**FINAL ENVIRONMENTAL IMPACT REPORT
STATE CLEARINGHOUSE NO. 2017091011**

**RIALTO BIOENERGY FACILITY PROJECT
CITY OF RIALTO
SAN BERNARDINO COUNTY, CALIFORNIA**

February 2018

Figure 3.8: Process Flow Schematic

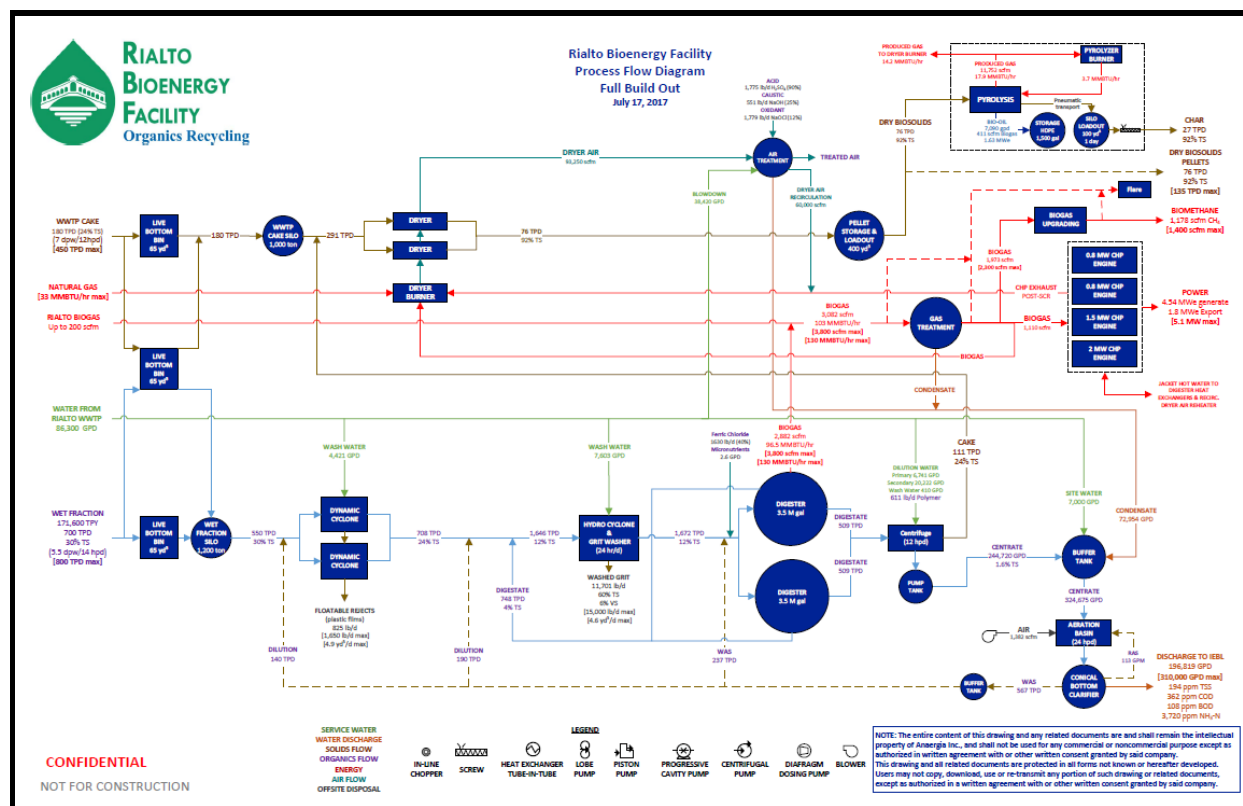
Is there a breakdown available of approximate daily tonnages for each type of material received daily (waste type)? On the flow chart, Figure 3.8: Process Flow Schematic, it says the wet fraction will be 800 TPD max and the WWTP Cake will be 450 TPD max which is a total of 1250 TPD and in 3.5.1 Overall Facility Operations 1,080 tons per day of material will be used. Additionally, it would be helpful if
